10.3 Main Steam Supply System

The information in this subsection of the reference ABWR DCD, including all subsections, tables, and figures, is incorporated by reference with the following departures and supplements.

Figure 10.3-1 Main Steam Supply System

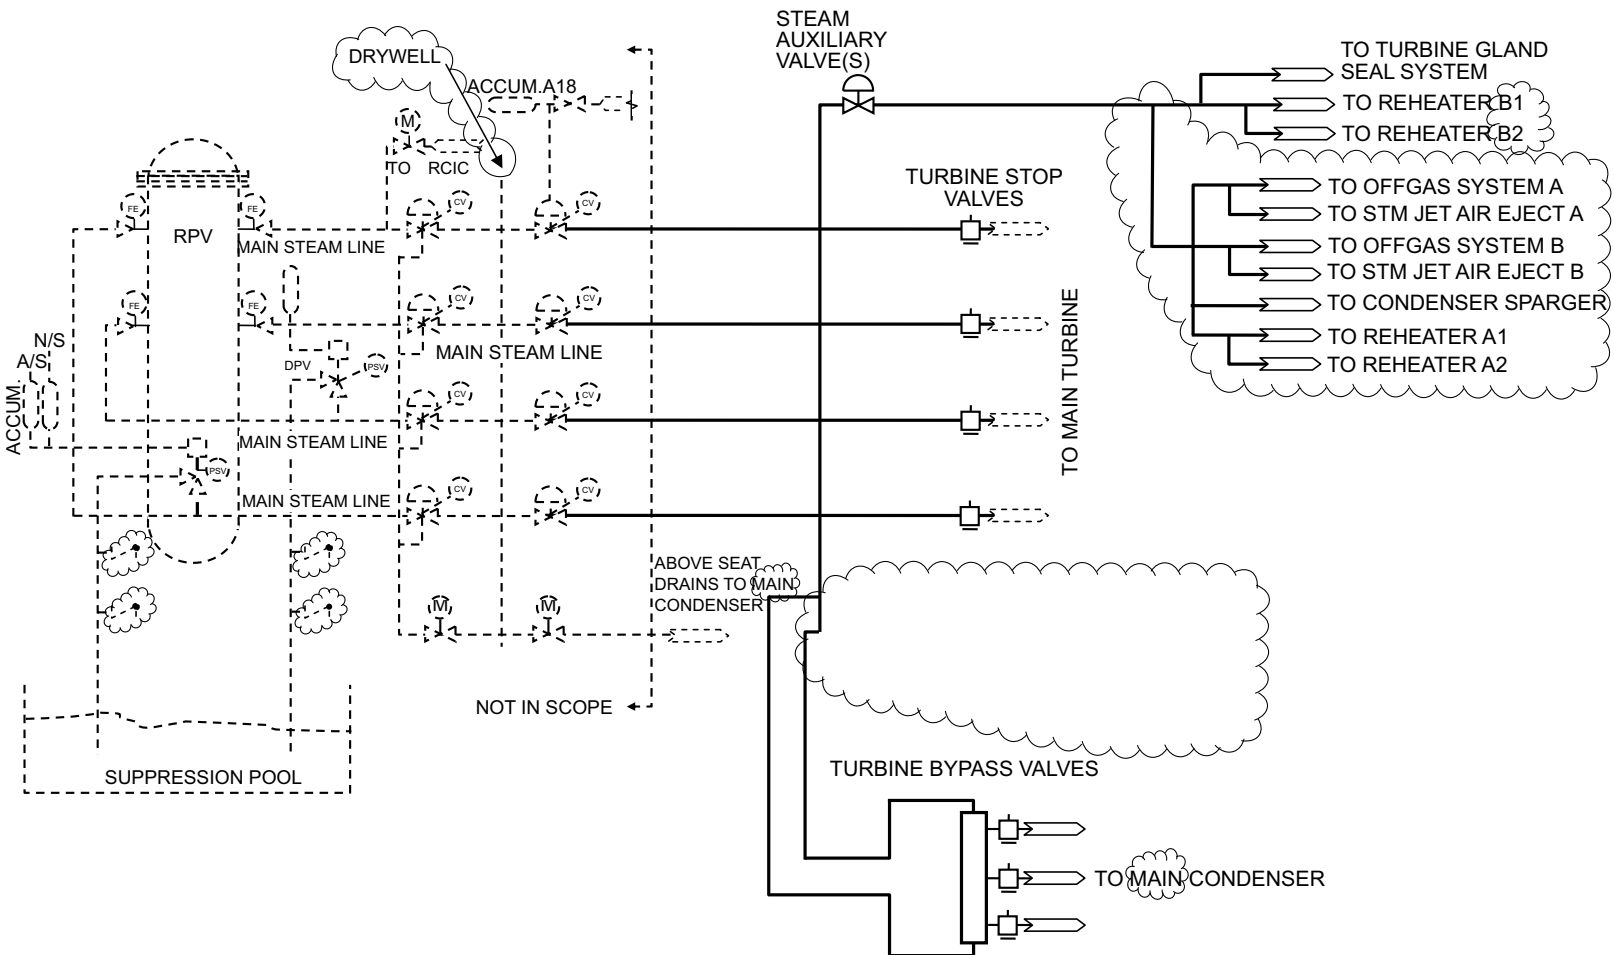
STP DEP 10.2-1 (Table 10.3-1, Figures 10.3-1 and 10.3-2)

~~A drain line is~~ Drain lines are connected to the low points of each main steamline, both inside and outside the containment. Both sets of drains are headered and connected with isolation valves to allow drainage to the main condenser. To permit intermittent draining of the steamline low points at low loads, orificed lines are provided around the final valve to the main condenser. The steamline drains, ~~except~~ including the drains through the Control Building, maintain a continuous downward slope ~~from the steam system low points to the orifice located near the condenser. The drain line from the orifice to the condenser also slopes downward~~ in the direction of flow to the steam system line drain low points in the Reactor Building steam tunnel and then slope upward to reach the high point in the steam tunnel above the Control Building. From

Figure 10.3-2 Main Steam Turbine System

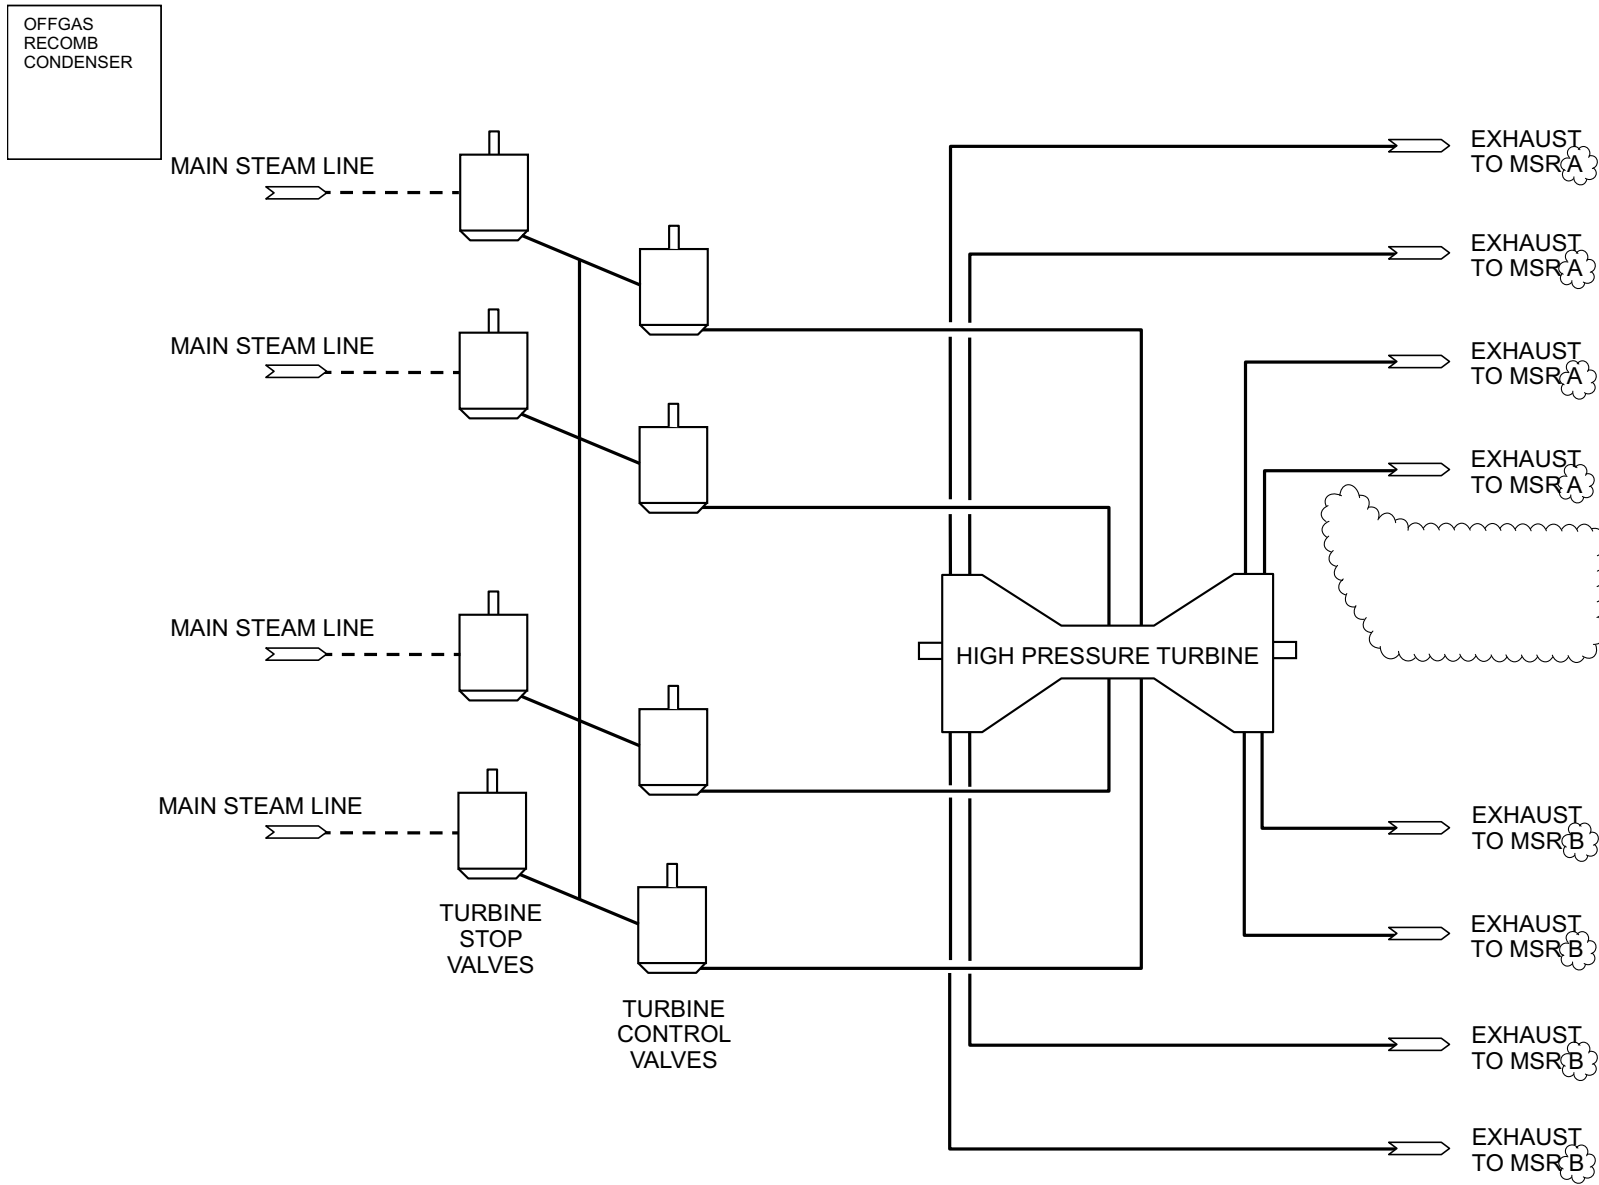
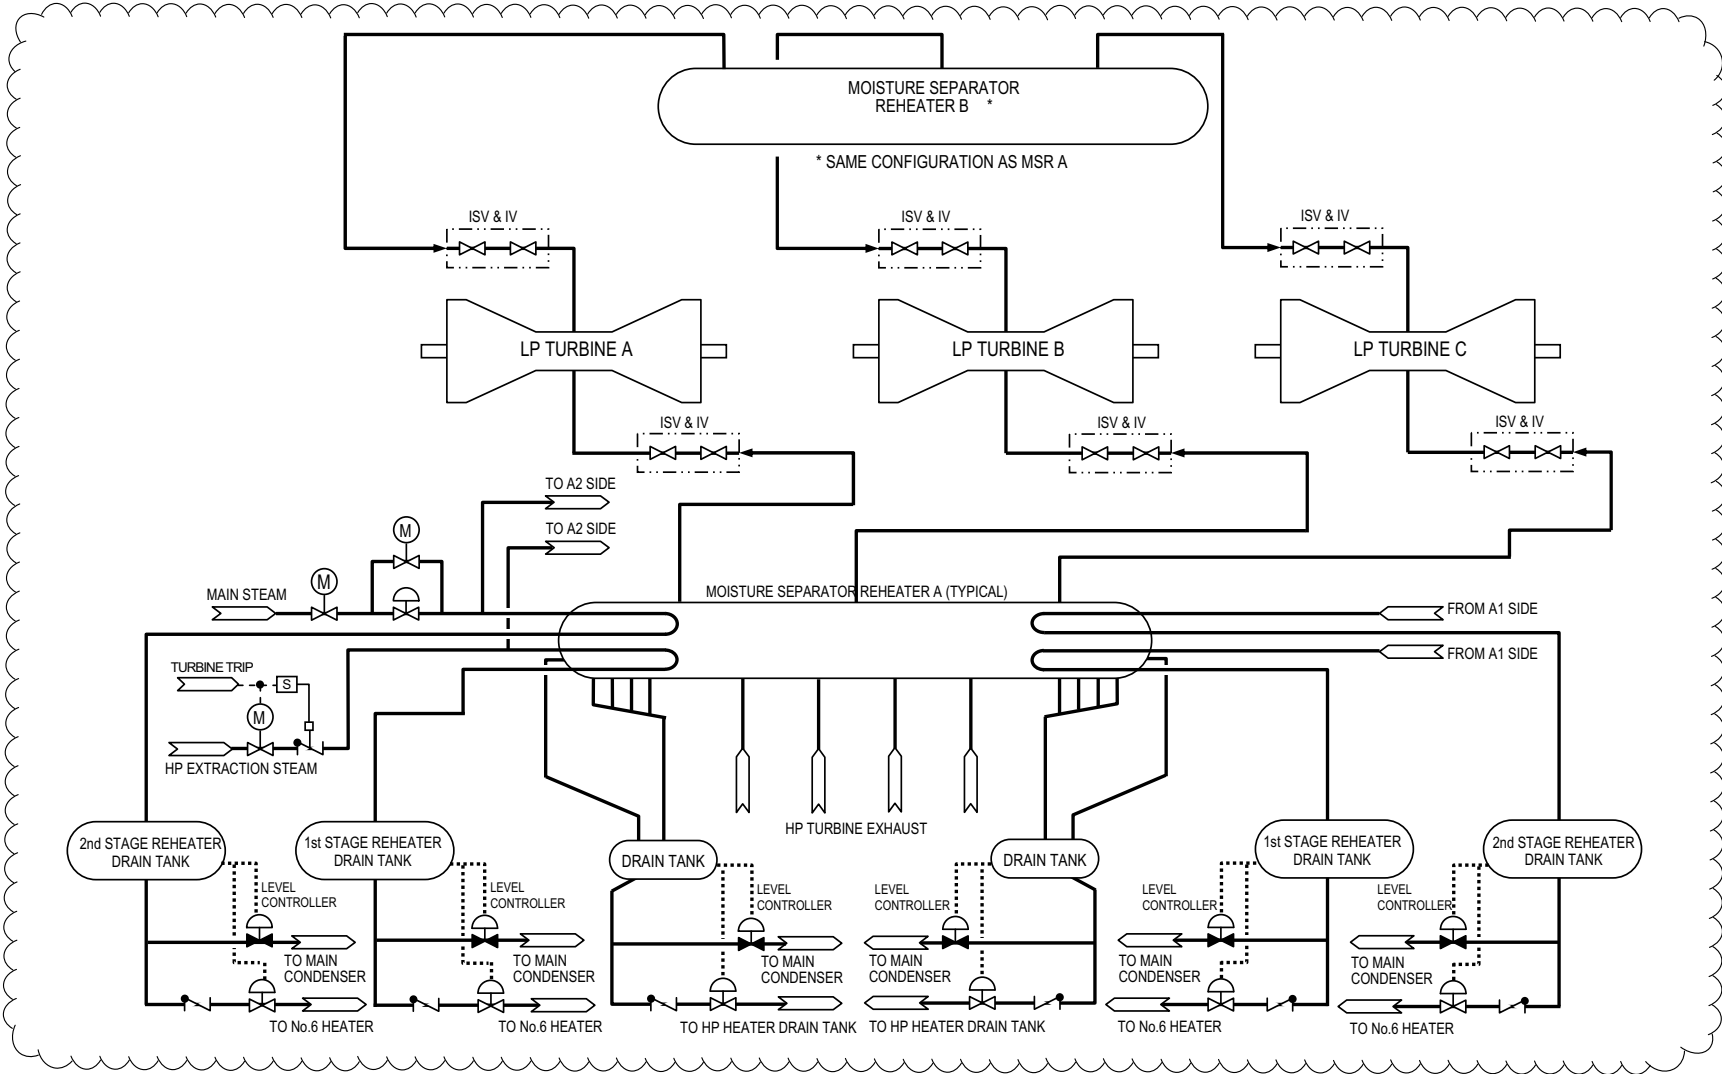
STP DEP 10.4-3 (Figure 10.3-2)
